Product Change Notification

Business Unit	Product Line Code	Type of Change	Action	Date of Issue
AI - Automation Infrastructure	DNA	Product Change Notification	Notify Distributors and Field	12/14/2023

Part #	Type Description
2981059	PSR-SCP- 24UC/ESL4/3X1/1X2/B
2981062	PSR-SPP- 24UC/ESL4/3X1/1X2/B

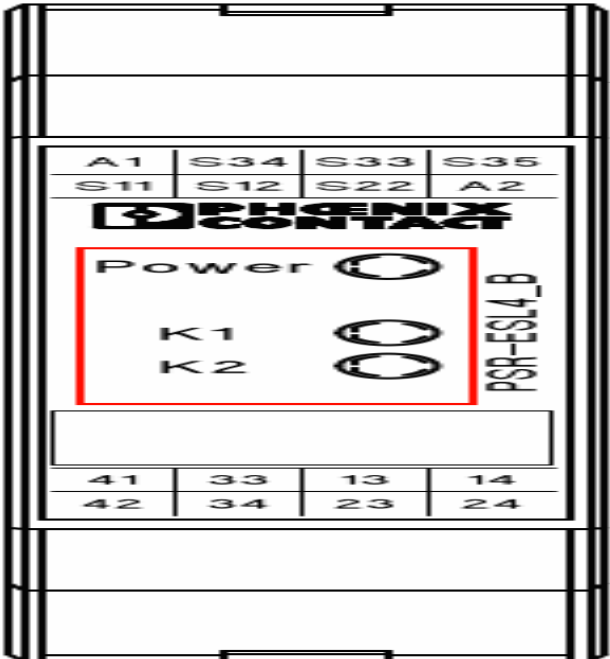
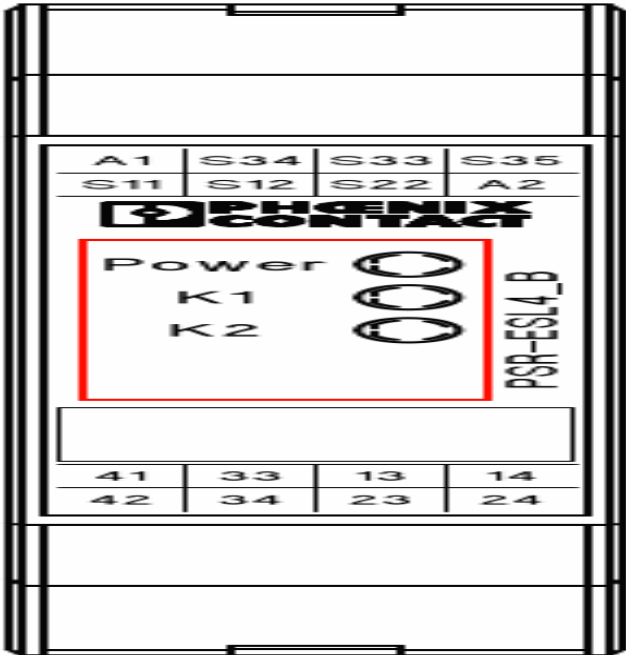
Due to the hardware change, the listed items can no longer be operated via an AC supply voltage, and are therefore only compatible with old item versions to a limited extent. The modified technical values are listed in the attachment. In addition, non-coded plugs will be installed, the packing slip will be changed over to a new documentation concept, and a smaller folding carton will be used.

In addition to the year of manufacture, the calendar week will also be displayed below the CE mark. The various pictograms and TÜV approvals will be displayed in the lower area on the left half of the housing . The LEDs on the front will be repositioned and the connectors will no longer be coded.
